10461 Hook Lane, Pagham

Technical Note 4 Rv01: Response to LLFA Comments on RMA

31st March 2021

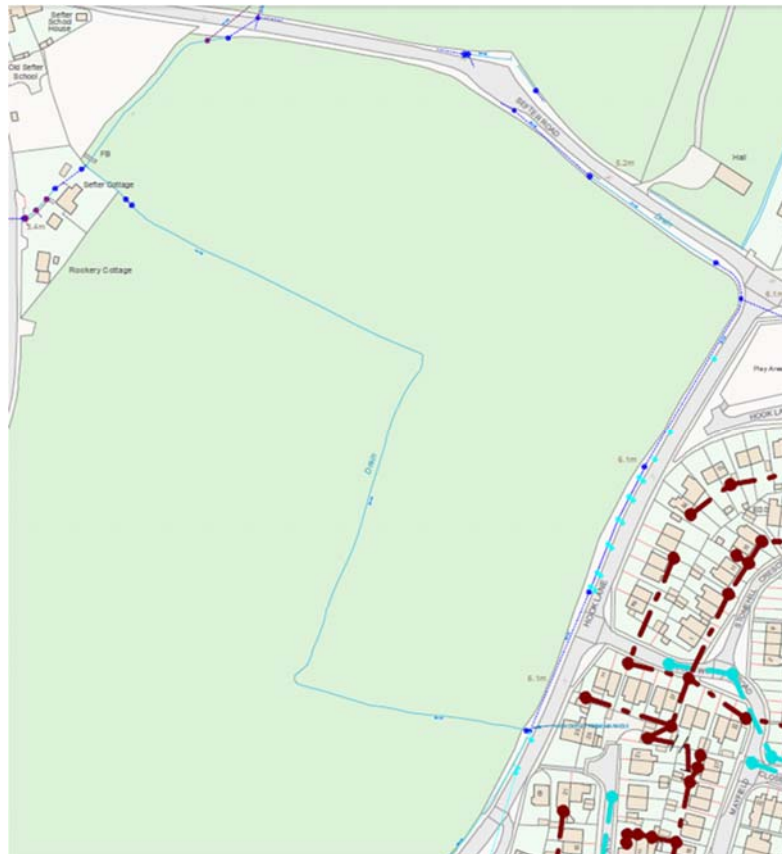
2.5.1.1 *Your proposals for the swale show a downstream invert level of 3.29. But on the topographic survey levels are currently 3.78-3.66 in this area. Without knowing the culvert invert levels in the area and the downstream watercourse levels it is not possible to know whether this is achievable in practice*

We are trying to replicate the existing situation as closely as possible and the existing information we have suggests this is the case. It has also been noted that the outfall to the east eventually flows north along Hook Lane and Sefter Road back to Sefter Cottage, therefore ultimately outfalls to the same point. As shown on the Extract from ADC Mapping dated 02 November 2020.

These are small check dams to replicate the existing long fall. If the dams are omitted the bed would be steepened and change the rate of discharge at this end of the site.

| Appendix C – Existing Exceedance Flow Plan

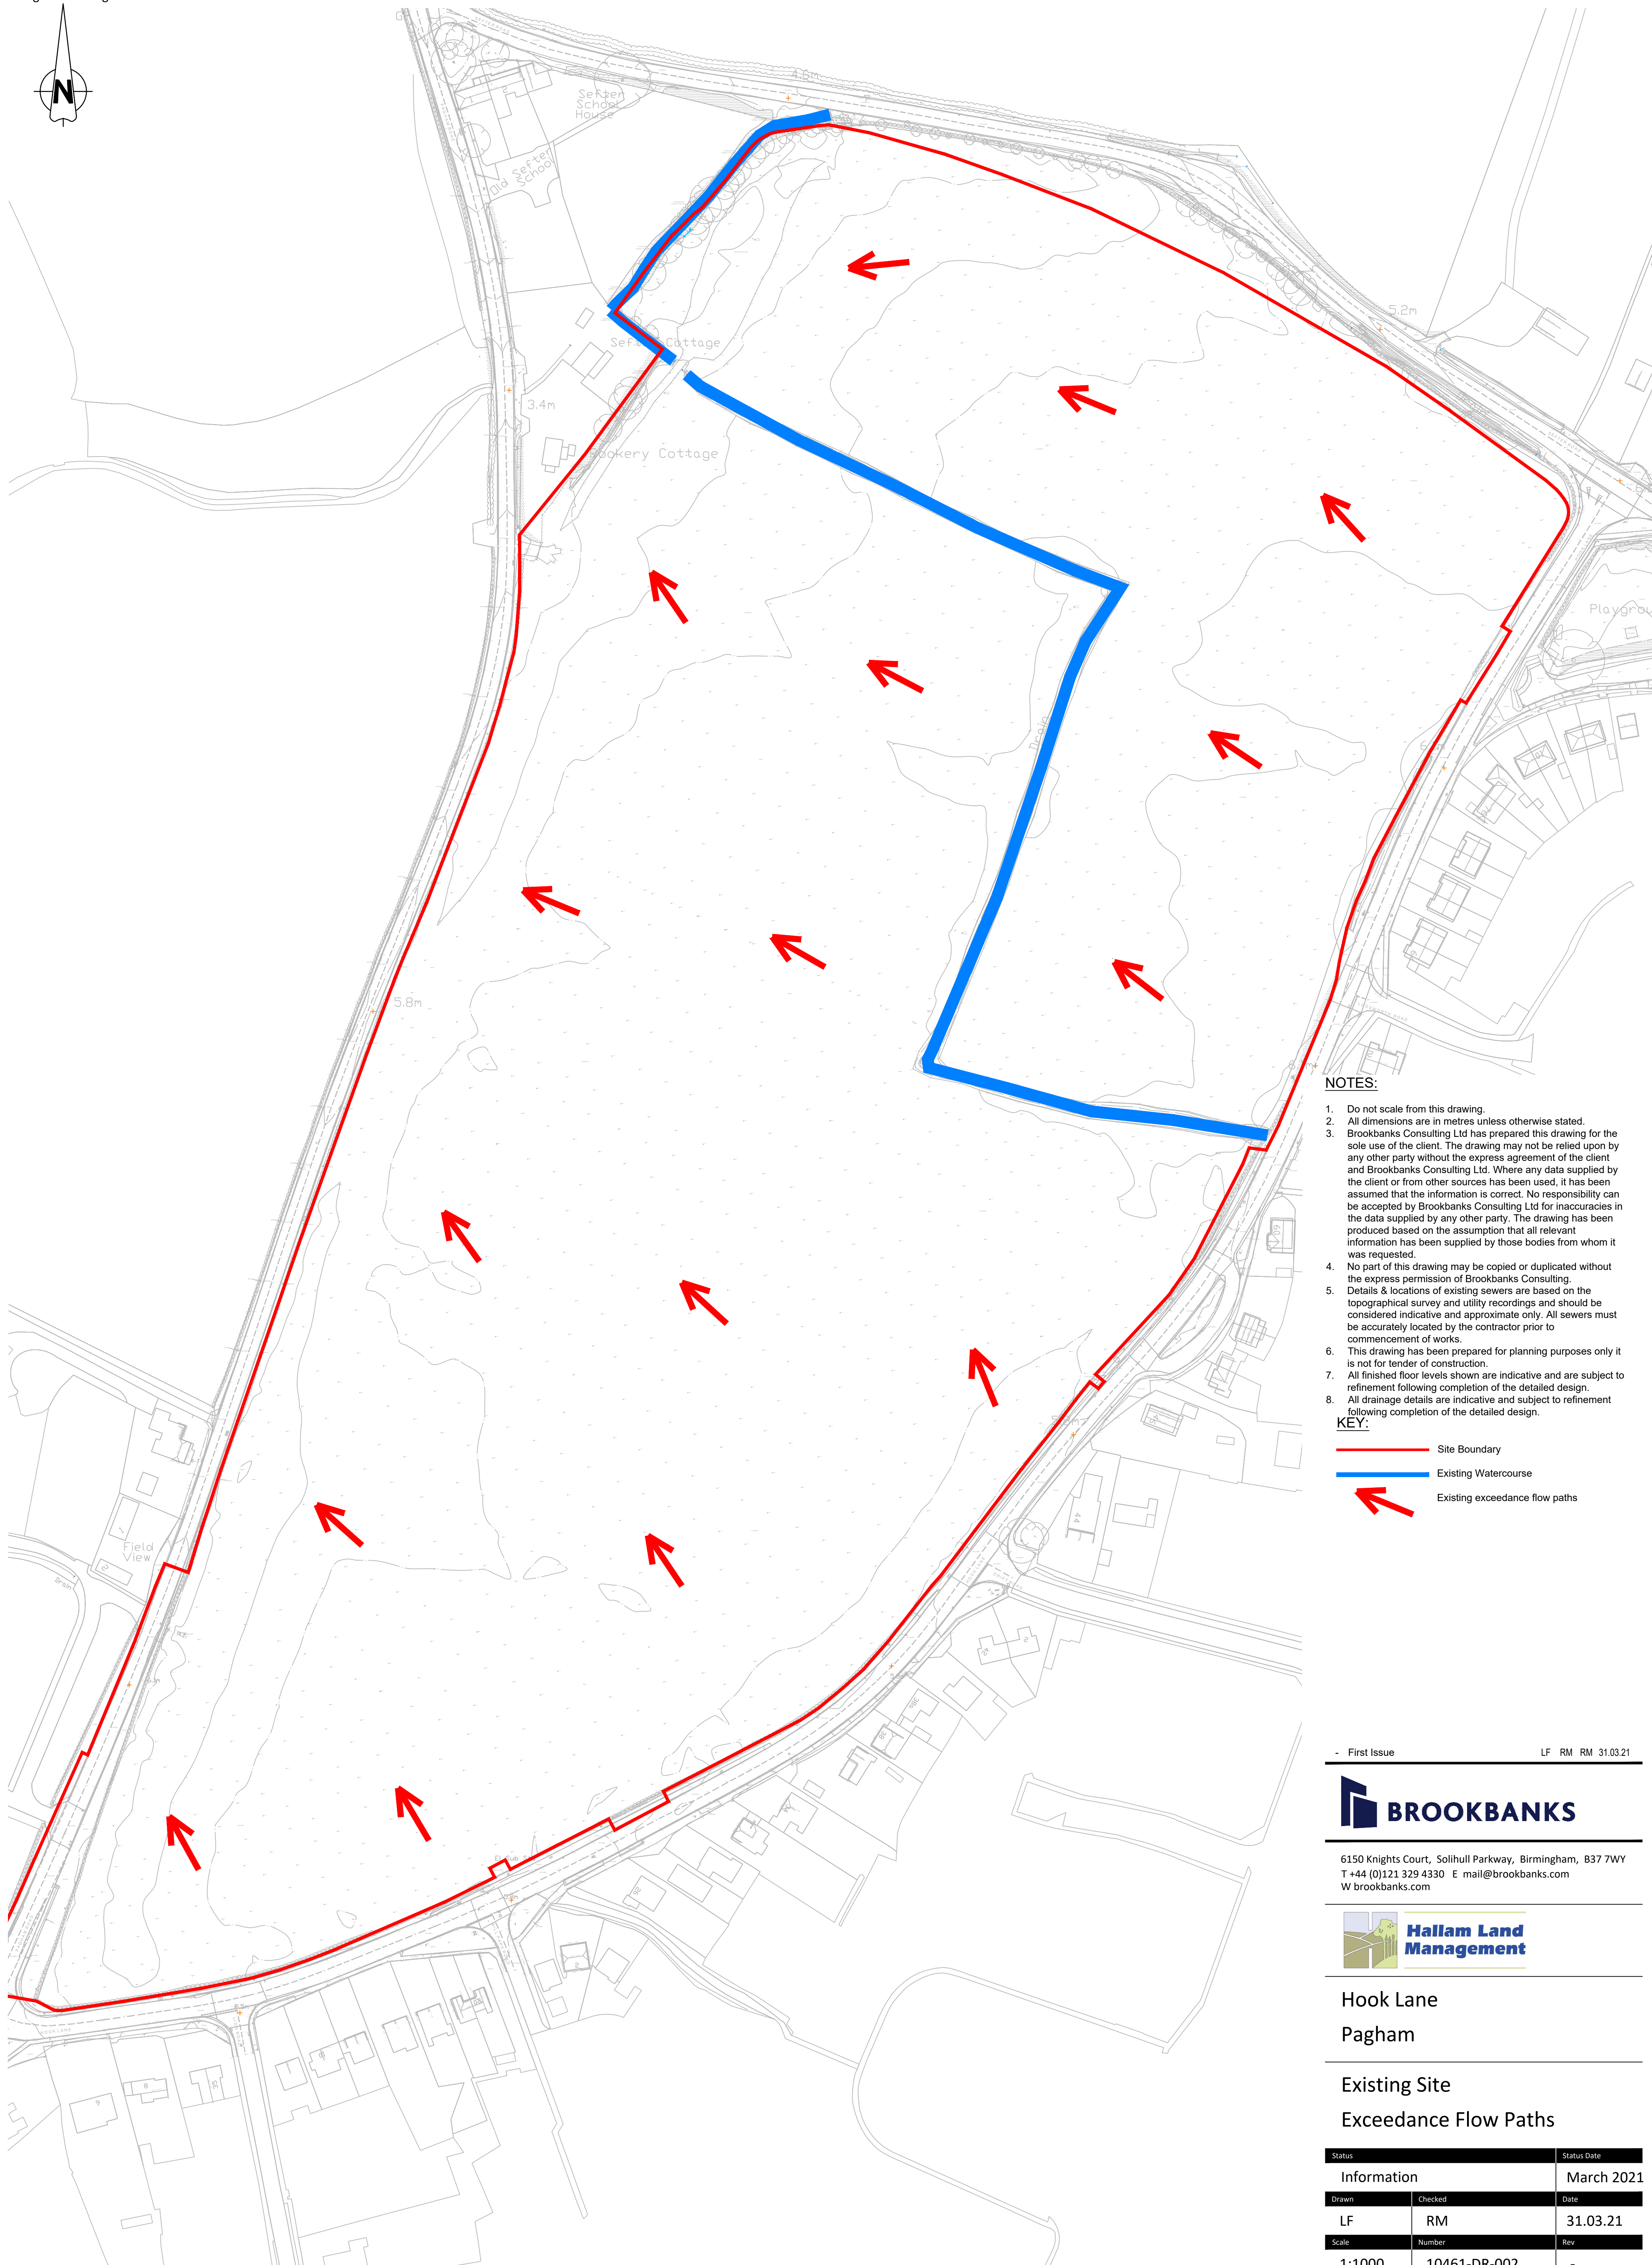
- 2.7** The proposed drainage strategy shows all water discharge to one location the surface water drainage strategy must follow existing natural catchments.

- 2.7.1.1** *The exceedance plan does not accurately represent the natural catchments at this site. Land to the south is believed to drain to the watercourse which runs near to Windmill Barn. This connection should be investigated and utilised. If it is not we will expect discharge rates to be restricted, i.e. the flow restriction for catchment 1 will need to be reduced down to ensure that flows to the Seftor Cottage area are not increased.*

- 2.7.1** *We have sought as far as reasonably practicable to mimic the status quo found on site and direct proposed discharge points to suitable locations. Please refer to the exceedance plan in the appendix for further details.*

The site layout is proposed to mimic the existing situation as closely as possible however the flat nature of the site present challenges with placement of SuDS for treatment and attenuation upstream of an outfall. The proposal is to restrict the flow to below Qbar thereby greatly reducing the existing flood risk at Seftor Cottage. The existing connection is proposed to be retained and will therefore provide another outfall in exceedance events.
